Introduction

This document addresses transceiver-related known errata for the Stratix® GX FPGA family production devices.

Figure 1. Gigabit Transceiver Block Clock Configuration that Does Not Cause Byte Misalignment Problem

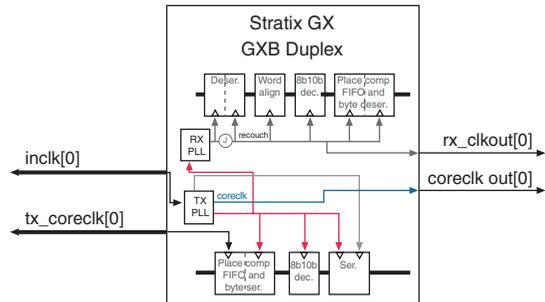
This problem will only occur if the read clock of the phase compensation FIFO of a channel is fed from a clock source other than its own recovered clock. For example, [Figure 1](#) shows a clock configuration that avoids this problem:

From [Figure 1](#), the recovered clock (`rx_clkout[0]`) is fed to both the read and write clocks of the phase compensation FIFO. This is the default configuration of `ALTGXB` megafunction. The Quartus® II software automatically routes the clocks into both sides of the FIFO to ensure that proper timing is met.

Figure 2. Gigabit Transceiver Block Clock Configuration that can Potentially Cause Byte Misalignment Problem, Example 1

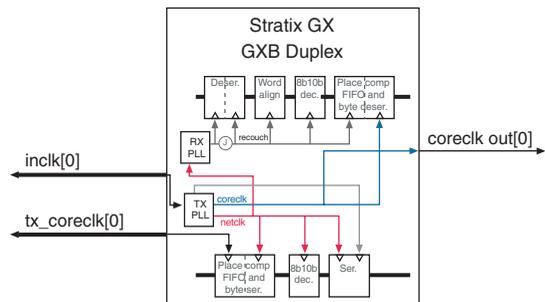
Byte misalignment may happen in the double width mode (16-bit or 20-bit) on the received data in certain configurations of the gigabit transceiver block. On the transmit side, the byte ordering is specified to always shift the bits from the least significant byte to the most significant byte. On the receive side, this yields a possibility of two variations of the ordering, depending on where the comma falls in respect to when a clock recovery unit locks. These two variations are described in the *Stratix GX Transceiver User Guide*.

However, if a free running synchronous clock is connected to the rx_coreclk port and the gigabit transceiver block receiver is configured to be in double width mode, the byte ordering can have six possible combinations. The reordering happens when the receiver is coming out of the rxdigitalreset. Any byte misalignment that happens at this time will not subsequently change unless the reset is asserted again.

[Figures 2](#) and [3](#) show clocking schemes with potential byte misalignment problems.

The recommended workaround is to run the gigabit transceiver block in the default clocking scheme, as described above, and implement a phase compensation FIFO in the FPGA logic array. This configuration of the gigabit transceiver block will prevent byte misalignment. This would utilize additional resources and increase latency in the datapath. A phase compensation FIFO can be implemented in the FPGA logic array using a Dual Port RAM, however you decide on the FIFO parameters to meet system specifications. Another thing to be aware of is the additional clock resources needed for this implementation. Each channel will require the use of a global, regional, or fast regional routing resource for the recovered clock (`rx_clkout`) to be routed out of the gigabit transceiver block. Figure 5 shows an example of this workaround.

Figure 6. Transmit Phase Compensation FIFO Clocking Across Quadrants over IQ Lines

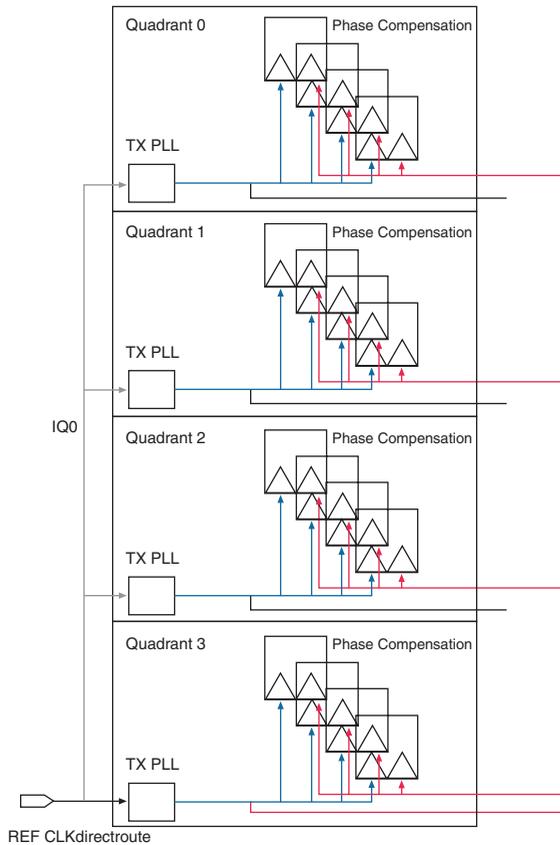
Figures 6 and 7 show the clocking schemes allowed for transmit phase compensation.

FIFOs that share a transmitter PLL `refclk` output from one transceiver block across transceiver blocks. **Figure 6** shows IQ routing used for the `refclk` output across quads. **Figure 7** shows global clock routing being utilized.
